Wisconsin Department of Transportation

**Proposal #02: 1010-02-78, WISC 2016 248
 Madison - Portage
 STH 19 & CPR Overpass
 Structures
 IH 39
 Dane County**

This is Addendum No. 01, which provides for the following:

ADDENDUM NO. 01

Addendum No. 01
 ID 1010-02-78
 Revised Sheet 23
 July 7, 2016

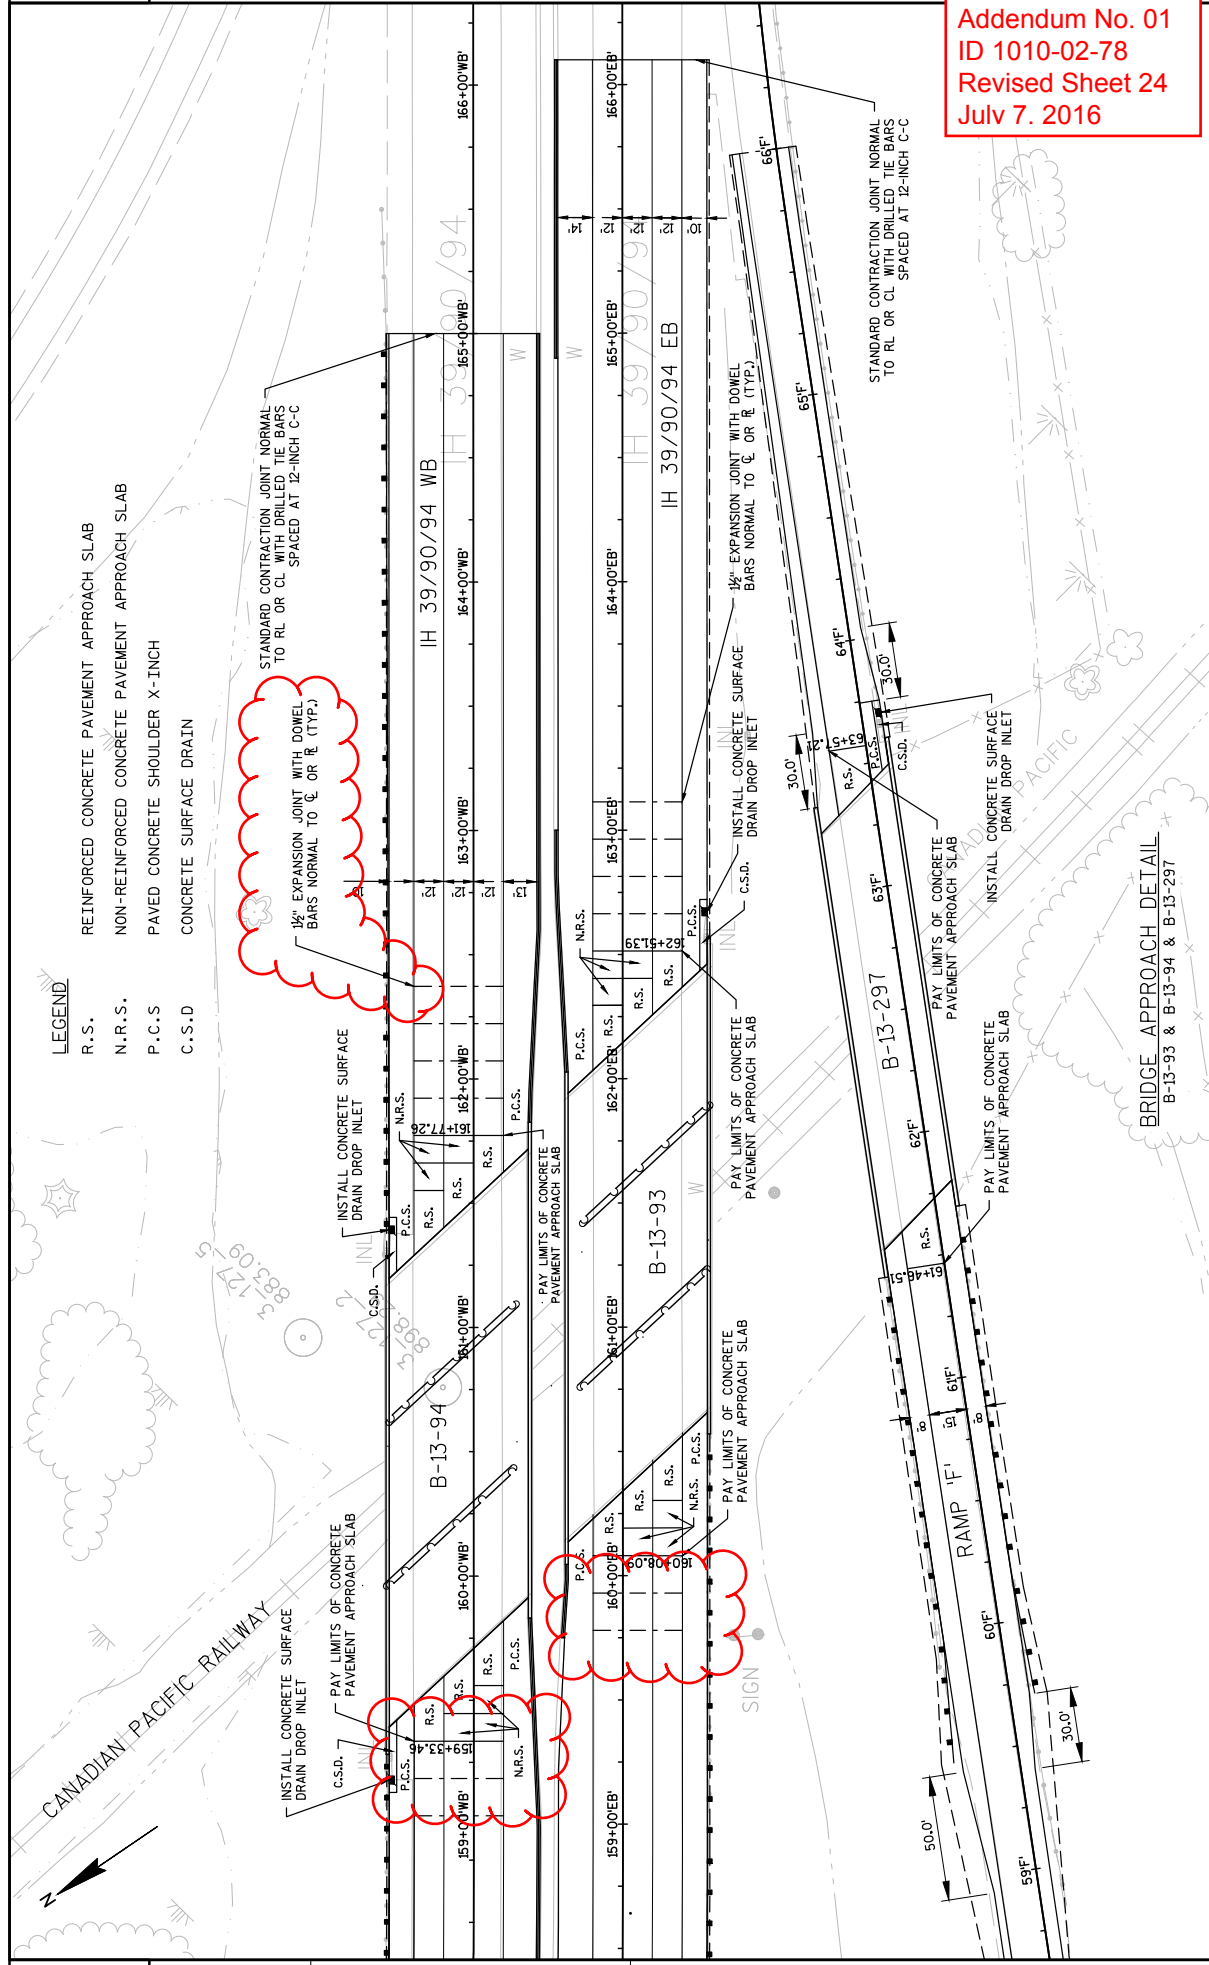
Revised Plan Sheets	
Plan Sheet	Plan Sheet Title (brief description of changes to sheet)
23, 24	Plan Detail: Bridge Approach Details (modified expansion joint locations)
106	Miscellaneous Quantities (added SPV.0090.07 Concrete Barrier Precast Left in Place)
352	Structure B-13-93 Quantities Sheet
373	Structure B-13-94 Quantities Sheet

1/2" EXPANSION JOINT WITH DOWEL BARS NORMAL TO CL OR CL (TYP.)

STANDARD CONTRACTION JOINT NORMAL TO RL OR CL WITH DRILLED TIE BARS SPACED AT 12-INCH C-C

1/2" EXPANSION JOINT WITH DOWEL BARS NORMAL TO CL OR CL (TYP.)

STANDARD CONTRACTION JOINT NORMAL TO RL OR CL WITH DRILLED TIE BARS SPACED AT 12-INCH C-C
